## Memorandum

Subject: Review of reports relating to hydrothermal activity and modeling of potential water table rise at Yucca Mountain, Nevada by TRAC-NA on behalf of the Nevada Nuclear Waste Project Office

**Comments on "Overview of calcite/opal deposits at or near the proposed high-level nuclear waste site, Yucca Mountain, Nevada, USA: pedogenic, hypogene, or both" by C.A. Hill, Y.V. Dublyansky, R.S. Harmon, and C.M. Schluter**

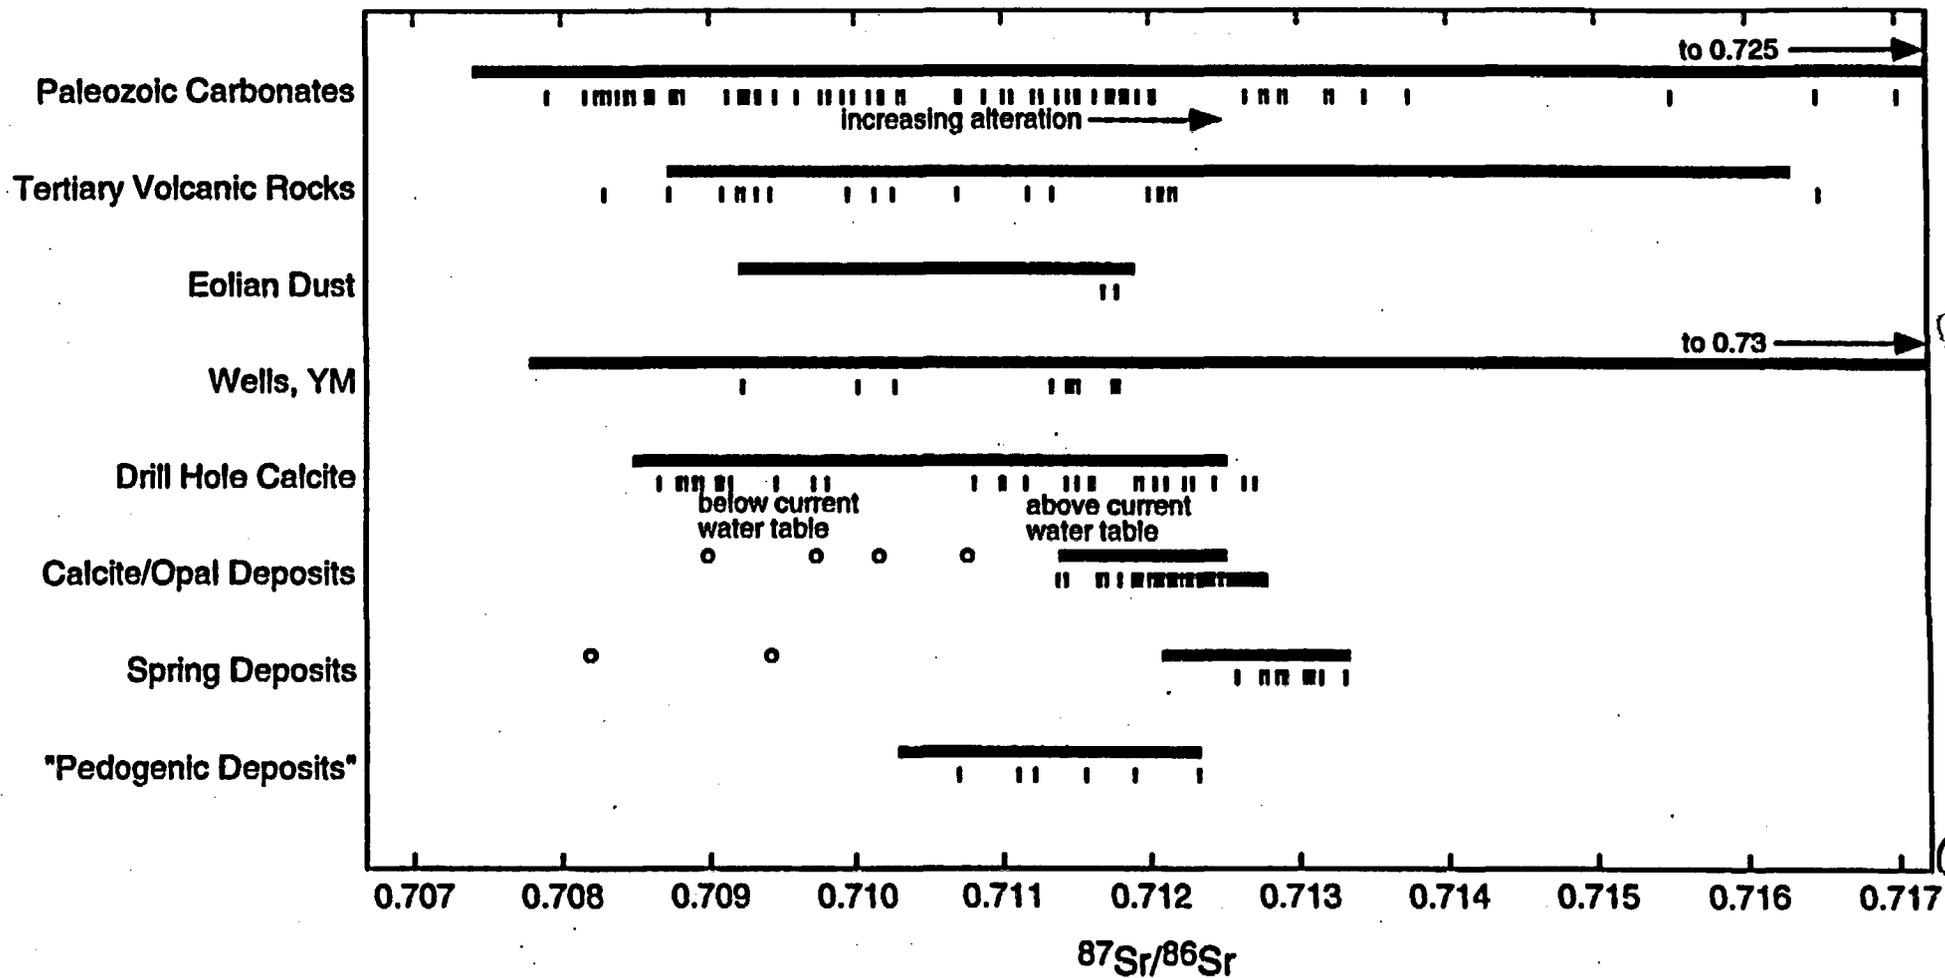
The strontium analyses best exemplify the selective use and/or misuse of data. Figure 1 presents a comparison of the plotted data ranges in Hill and others (1995, Figure 15) with the actual data points we believe belong in each sample category. We have taken the data from Hill and Schluter (1994), identified the samples that were plotted and the samples that should have been excluded. We did not plot the Precambrian range and samples because a realistic range for Precambrian rock is as great as the entire scale of either their or our diagram.

The range shown by Hill and others (1995) for eolian dust includes three residues from hydrochloric acid leaching used to remove the abundant carbonate fraction. These samples are identified as residues in Hill and Schluter (1994); there is no justification for including them here, especially inasmuch as there is abundant evidence that the silicate detritus contributes little or no strontium to the carbonate in the soils (Stuckless and others 1991; Marshall and Mahan 1994). The range for eolian material is drastically reduced when these samples are eliminated (Fig. 1).

Figure 15 (Hill and others 1995) is misleading in that it is drawn at two different scales such that any values shown to the left on the fine scale could be repeated to the right on the coarse scale. However, only the values for altered Paleozoic Carbonates and those labeled as "spring and wells, Yucca Mountain" are repeated on the right-hand side of the diagram. This has the effect of making the ranges appear larger than they really are. The range of strontium isotopic compositions for waters from "spring and wells, Yucca Mountain" greatly exceeds any measurements cited in Hill and Schluter (1994) or known to us. The correct range for the isotopic composition of well water from on or near Yucca Mountain is shown by the hatch marks on our Figure 1. (The label "spring and wells, Yucca Mountain" is erroneous because there are no springs on or near Yucca Mountain; the water table ranges from approximately 500 m to 700 m below the surface.)

The range for drill-hole calcite is accurate as shown. However, the use of a single bar to show the range obscures the fact that there are two distinct fields: those for samples from above the current water table, and those from below (Fig. 1). We are puzzled by the designations of deep-seated and shallow samples as Timber Mountain and Stagecoach Road calcites on Figure 15 of Hill and others (1995) because the terminology is not explained, and it certainly is not as germane to the data as the terms used by the authors cited above who collected the data.

The range shown for the calcite/opal deposits category is substantially correct, except that it does not extend far enough to the more radiogenic values. The four samples with the smallest

$^{87}\text{Sr}/^{86}\text{Sr}$  ratios (shown as outliers by Hill and others (1995)) are acid residues and are not representative of carbonate material.

The "groundwater spring deposit" category has two outliers as shown by Hill and others (1995, Fig. 15). The least radiogenic one is from the Wahmonie Mound, which is underlain by a different aquifer from the main aquifer at Yucca Mountain. Furthermore, its age and origin are unknown, but it probably represents a old hot spring deposit. The other outlier is data for an acid residue, and not representative of carbonate material. The range for the spring deposits category is further reduced by excluding samples from Devils Hole, which is not in the flow system that underlies Yucca Mountain. Thus we are left with 13 samples of spring deposits representing three sites south (and downgradient) of Yucca Mountain (Marshall and others 1993).
